Interim Technical Report

DIABLO CANYON UNIT 1
INDEPENDENT DESIGN VERIFICATION PROGRAM
HVAC DUCT AND SUPPORTS REPORT
ITR # 15 REVISION 0

Docket No. 50-275
License No. DPR-76

Figure No. 3
 Computer Model Duct Sample No. 1
 Vertical Run

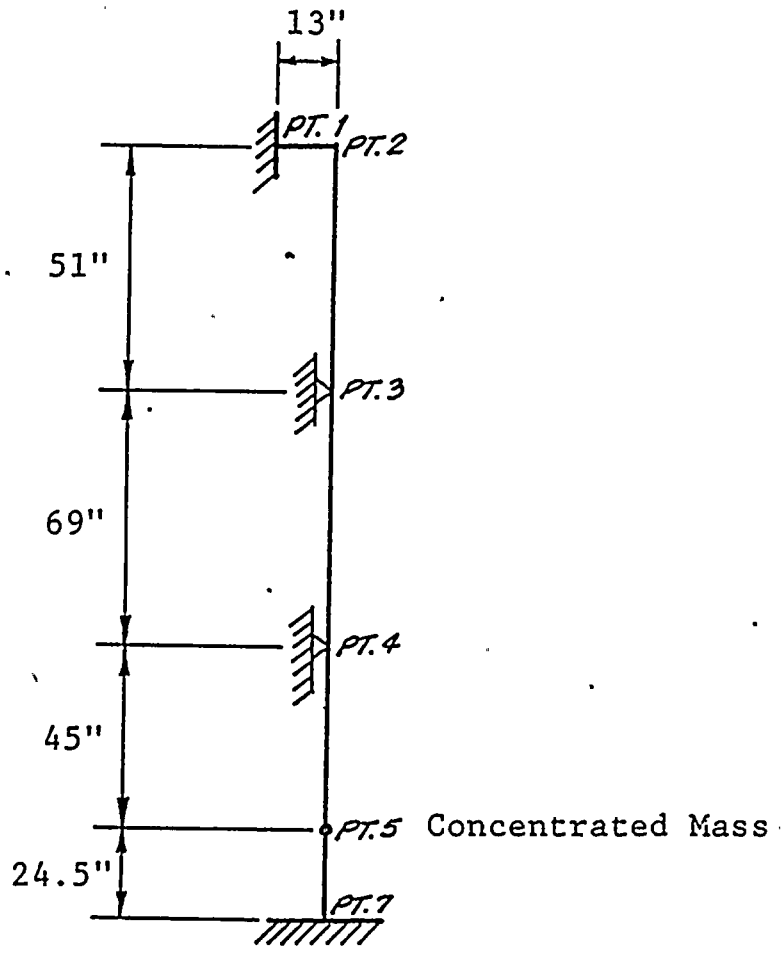
EOI 1110 was issued as a result of a difference between the field verified condition and the design drawing. The design drawing calls for angles on three sides of the duct at point 1 (Figure 3) for HVAC sample No.1. The IDVP field verification does not show these angles. The IDVP analysis which is based on the field verified conditions did not include the missing angles. This EOI is classified as a potential open item with future action by PGandE.

Figure No. 4
Duct Sample No. 2
12 Inch Duct

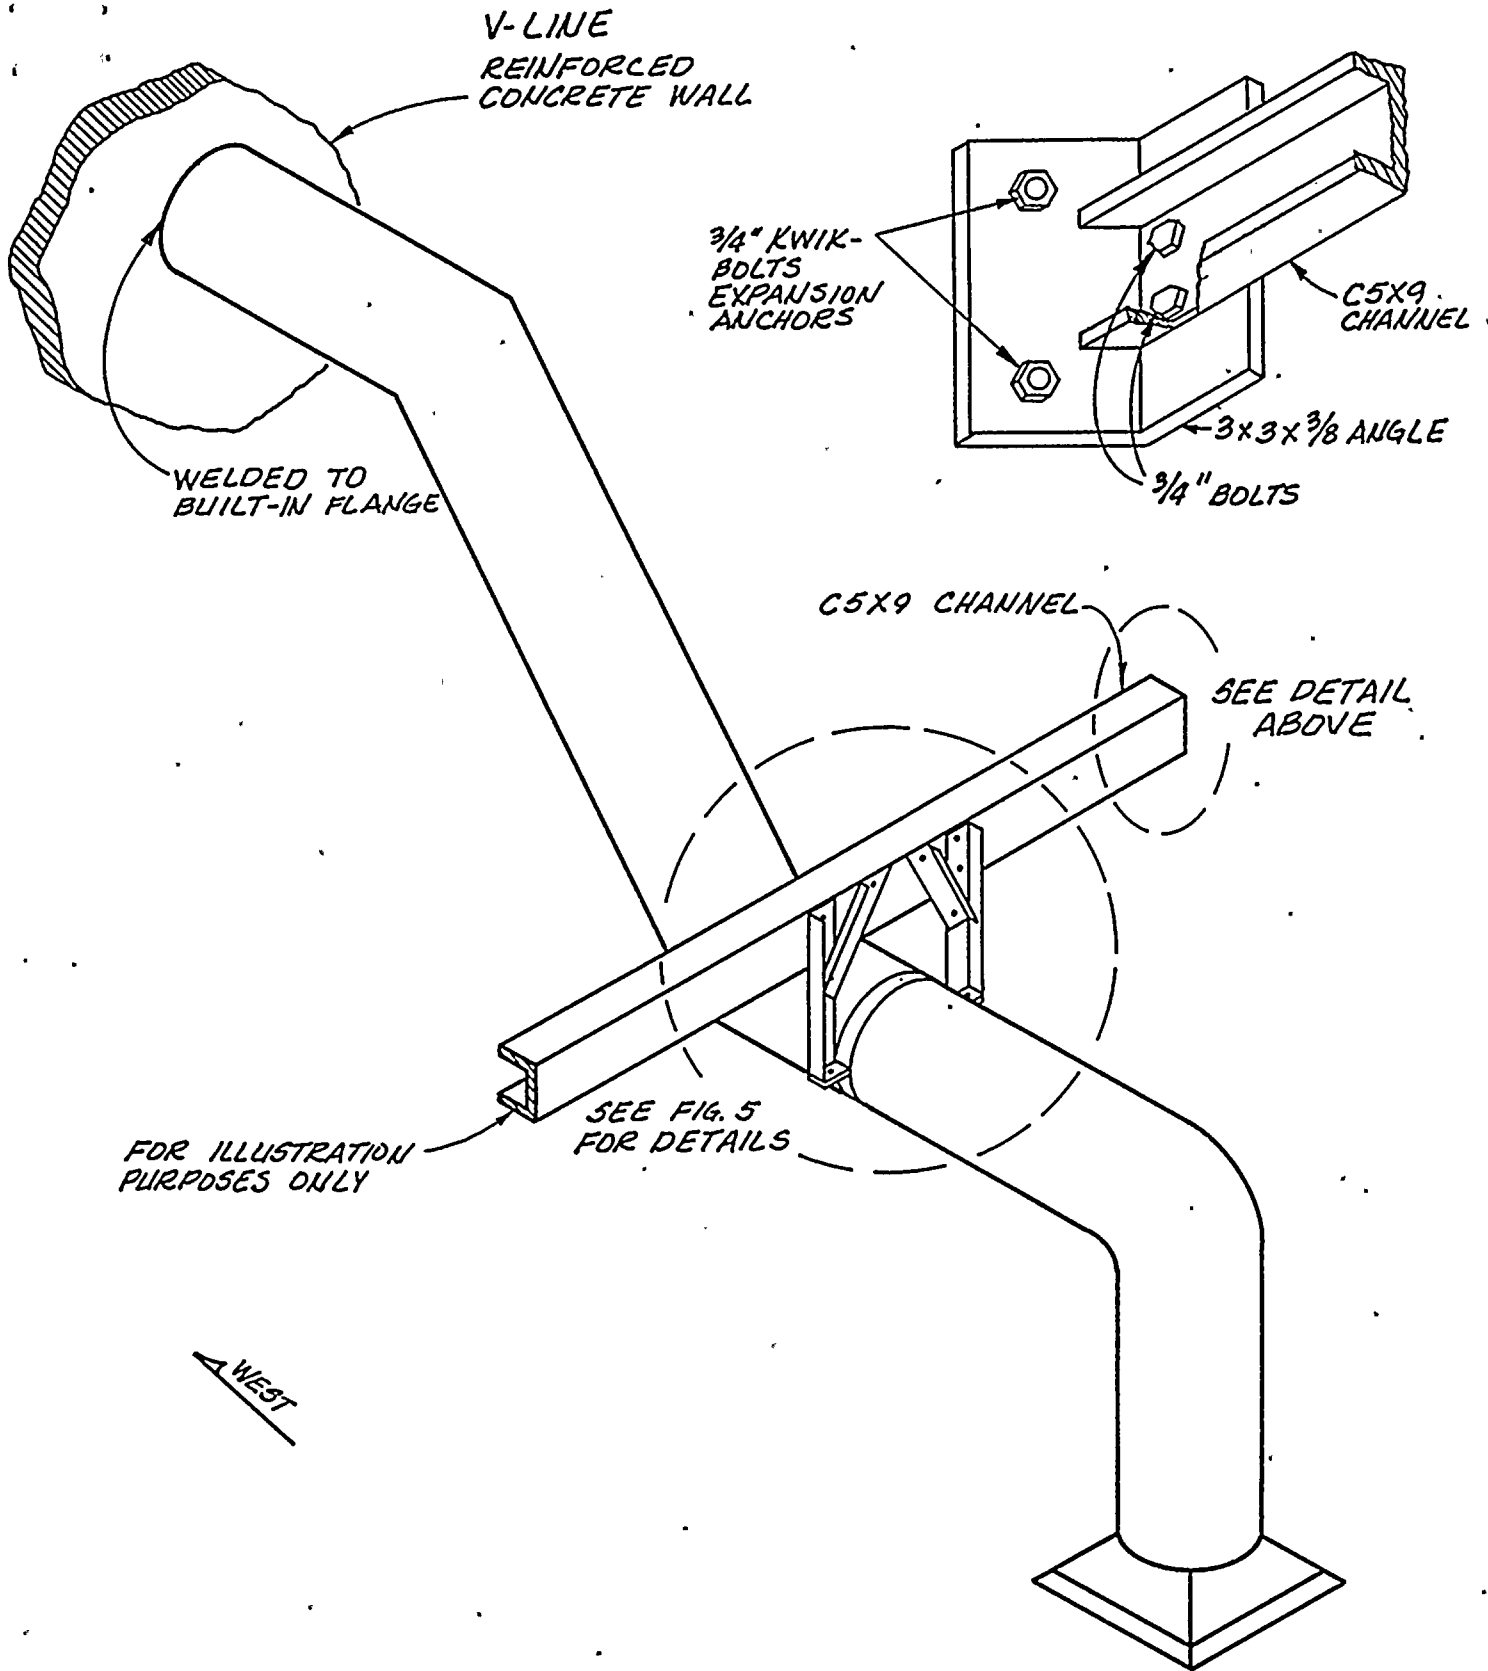
EOI 1077 was issued because the Hosgri qualification calculation for the duct support for duct sample No. 2 is dated November 8, 1981. A calculation dated prior to November 8, 1981 (Hosgri re-evaluation) could not be located. Therefore a concern was raised as to whether this duct support was reviewed for the Hosgri.
